**Item 4.****Section 4.55 Application: 65-77 Market St, Sydney - D/2017/167/A**

File No.: D/2017/167/A

**Proposal Summary:** The application is a Section 4.55(2) modification to amend a Stage 1 consent for a mixed-use building comprising retail and commercial uses within the existing 10-storey building with the proposed 22-storey tower form above accommodating residential apartments. The application seeks consent to amend the approved building envelope.

**Figure 24** - Envelope plan of northern (Market Street) elevation.

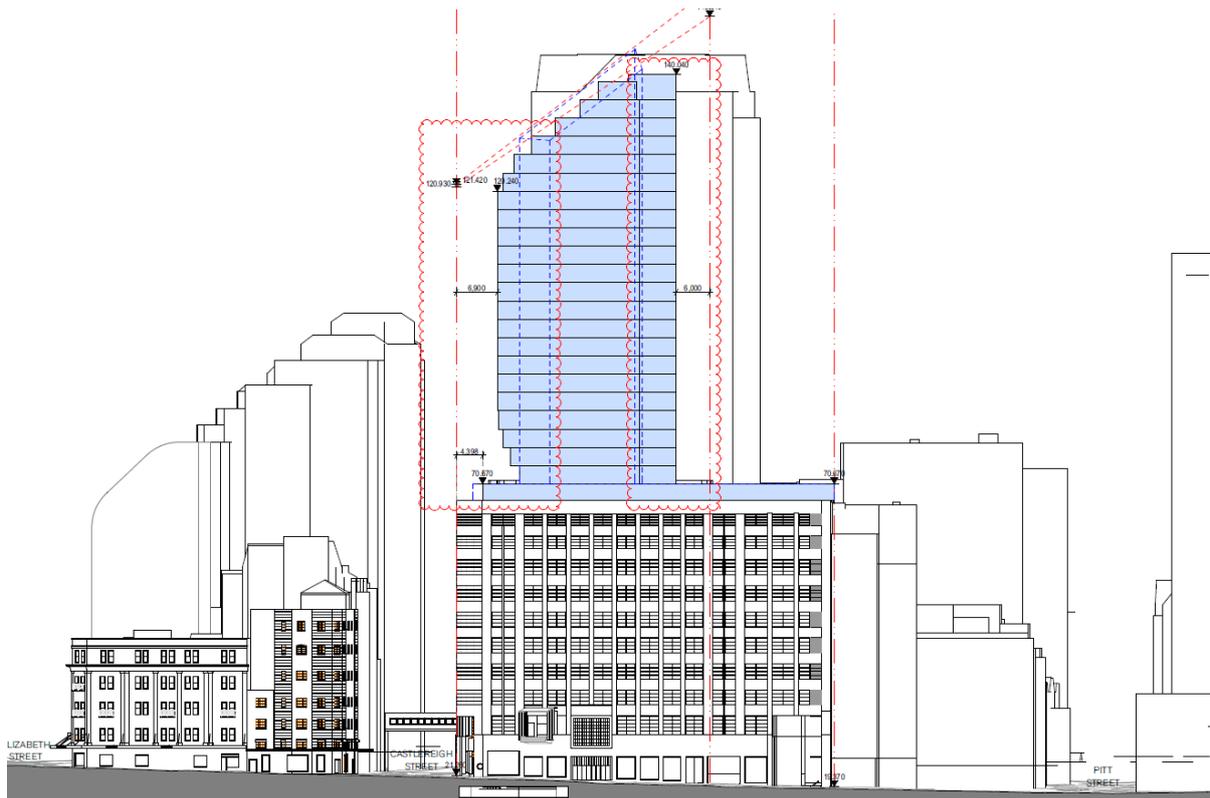
- (a) The tower setback on Market Street should be 10m to comply with the Sydney DCP 2012 and maintain the view corridor, as per the comments of the design competition jury.

25. The proposal was amended and considered again by the Design Advisory Panel on 12 September 2019. The Applicant presented 2 options to DAP, showing a 10m setback as well as a 9m setback to Market Street. It was outlined that the 10m setback required 9 structural columns within the existing heritage listed building to be strengthened internally to support the building envelope, as opposed to the 9m setback requiring localised strengthening of 6 existing columns.

26. The Panel made the following comments regarding the setback on Market Street:
- (a) The tower envelope in Option 2 with the 9m setback to Market Street is supported by the Panel.

27. As such, the amended proposal incorporates the following changes:
- (a) Decrease the minimum tower setback on the northern elevation to Market Street from 10m to 9m;
